LOCAL AND MUNICIPAL DEPARTMENT.

Report on a scheme for the improvement of the drainage of Karúr.

The Scheme.

Memorandum on the Acting Sanitary Commissioner's remarks on the Karur Drainage Scheme.

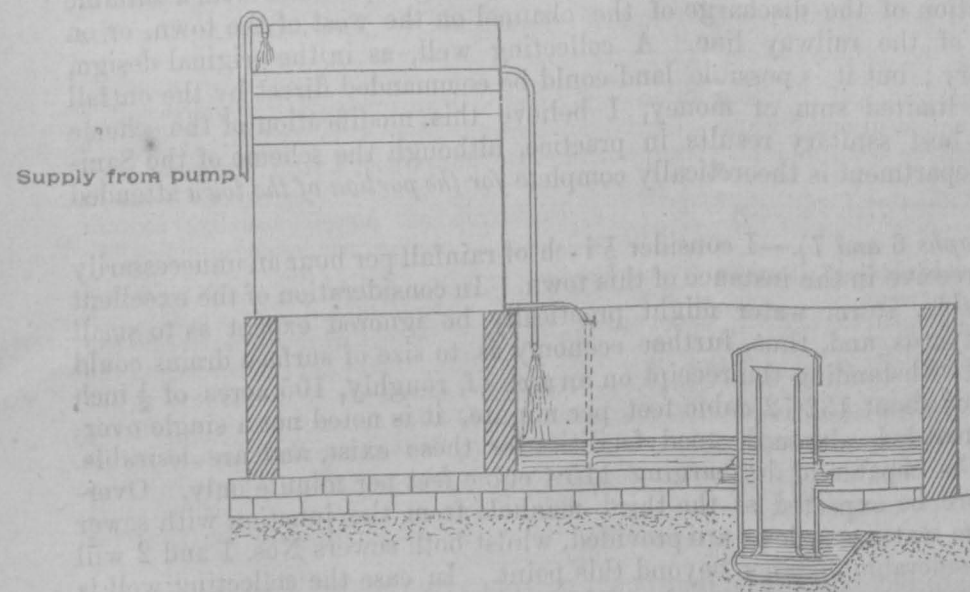
IV. *Sewage Farm*.—Whether the Rs. 2,000 includes compensation or not for ground is not stated. Likewise, neither the nature of the soil and its suitability for sewage farming, nor whether it is to be underdrained is stated. No value for land acquired nor for the realignment of streets or houses is mentioned. None of these are trivial points, and should have been quoted. It would not be advisable to take up a site for the sewage farm liable to flood.

No specification, or reference to the standard plans, is afforded as to the form of the manholes, nature of joints of stoneware pipes, or name of the maker.

In my opinion the silt traps are bad in form; no idea is given as to the position of these.

8. The manholes will be of the standard type proposed for Negapatam, the drainage scheme for which town has been approved by the Chief Engineer, Public Works Department. Messrs. Burn and Co.'s stoneware pipes have been estimated for. They will be jointed with cement with an inner ring of tarred yarn.

9. The silt traps are economical and their efficiency has been practically tested. Their positions are marked on the sections of streets.

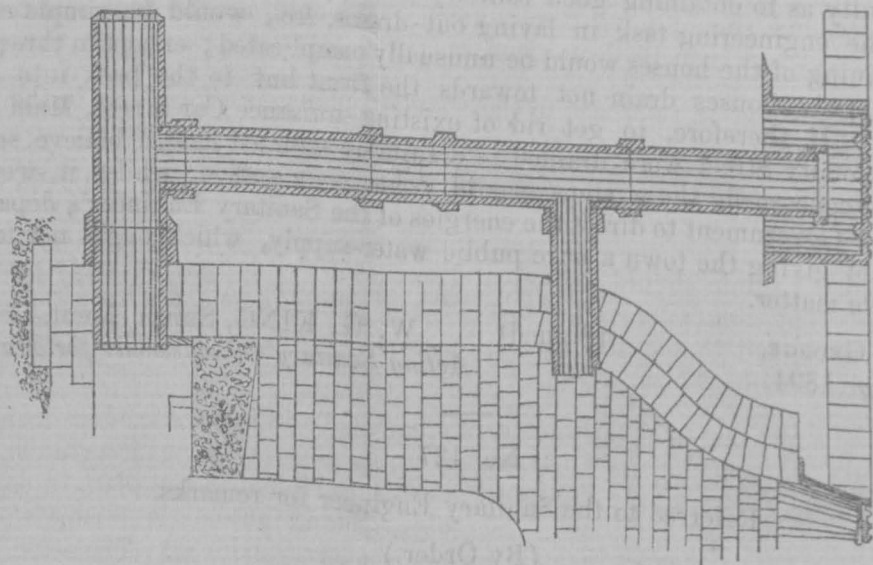
Automatic syphons are of such various descriptions, and their efficiency differs so greatly, that the maker's name should have been specified. By most makers it is

laid down as a *sine qua non* that a free air inlet should be arranged for in the syphon chamber to allow of venting the syphon readily, it being, in fact, stated that without this the syphon will not work. Possibly, the form selected by the Sanitary Engineering department will work without this precaution; but the usual arrangement adopted in consequence of this belief is as follows:—

Irrespective of the syphon question, this being the head of the sewer it would be better that it be ventilated. The plan leaves it to imagination how the syphon flush chamber is to be entered for cleansing, regulating flow, &c.

10. The iron tank holds water sufficient to charge the syphon twice. A flush is most needed when the sewers run at their lowest. This is usually between 12 and 3 P.M., or between 9 P.M. and 3 A.M. These are inconvenient hours for a cooly to work, it is therefore considered best to store the full supply required in the iron tank, and so regulate the tap that the syphons will act about the time a flush is most needed. It is proposed to manufacture the syphon locally.

11. Dr. King has reproduced in his memorandum an illustration which he describes as a free air inlet arrangement. The exact function of this arrangement is to expel air from the syphon chamber as it is being gradually filled up. A simple opening in the side of the chamber near its top will serve the purpose of an air outlet efficiently. In fact, the arrangement shown by Dr. King is not applicable to the syphon proposed for Karúr. It can only be adopted when the syphon chamber is placed under a street, in which case it is not desirable to have an opening immediately over the top of the chamber as this would admit dust.

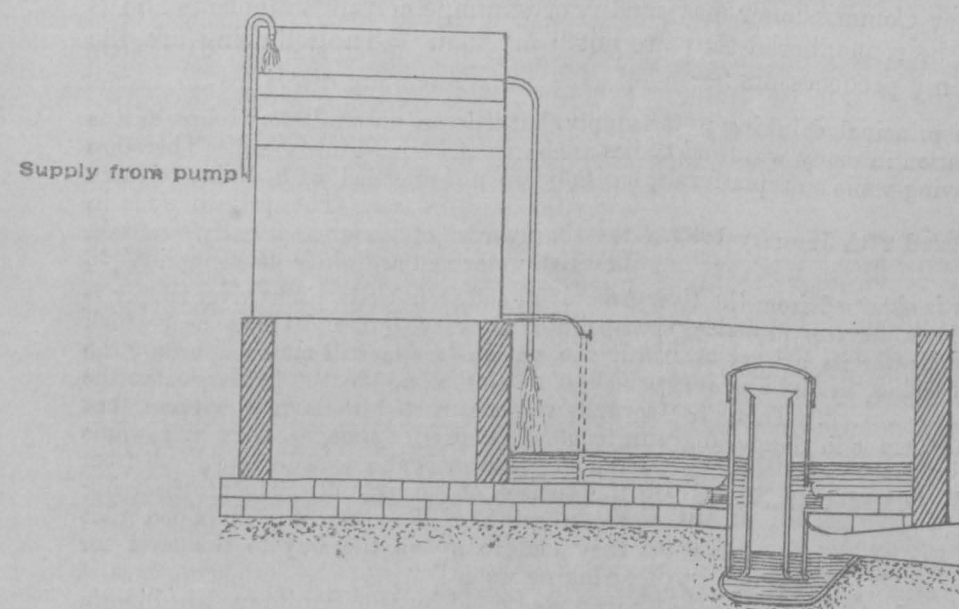
IV. *Sewage Farm*.—Whether the Rs. 2,000 includes compensation or not for ground is not stated. Likewise, neither the nature of the soil and its suitability for sewage farming, nor whether it is to be underdrained is stated. No value for land acquired nor for the realignment of streets or houses is mentioned. None of these are trivial points, and should have been quoted. It would not be advisable to take up a site for the sewage farm liable to flood.

No specification, or reference to the standard plans, is afforded as to the form of the manholes, nature of joints of stoneware pipes, or name of the maker.

In my opinion the silt traps are bad in form; no idea is given as to the position of these.

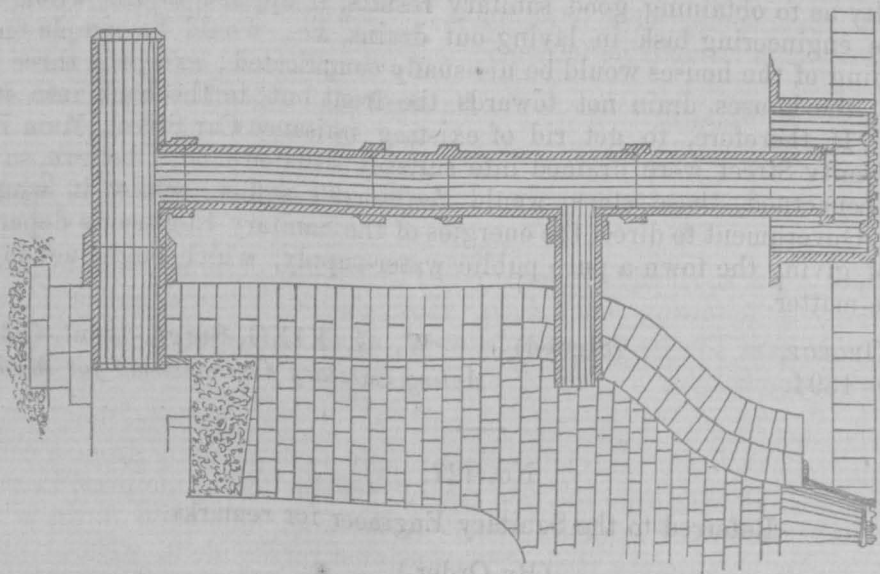
Automatic syphons are of such various descriptions, and their efficiency differs so greatly, that the maker's name should have been specified. By most makers it is

laid down as a *sine qua non* that a free air inlet should be arranged for in the syphon chamber to allow of venting the syphon readily, it being, in fact, stated that without this the syphon will not work. Possibly, the form selected by the Sanitary Engineering department will work without this precaution; but the usual arrangement adopted in consequence of this belief is as follows:—

Irrespective of the syphon question, this being the head of the sewer it would be better that it be ventilated. The plan leaves it to imagination how the syphon flush chamber is to be entered for cleansing, regulating flow, &c.
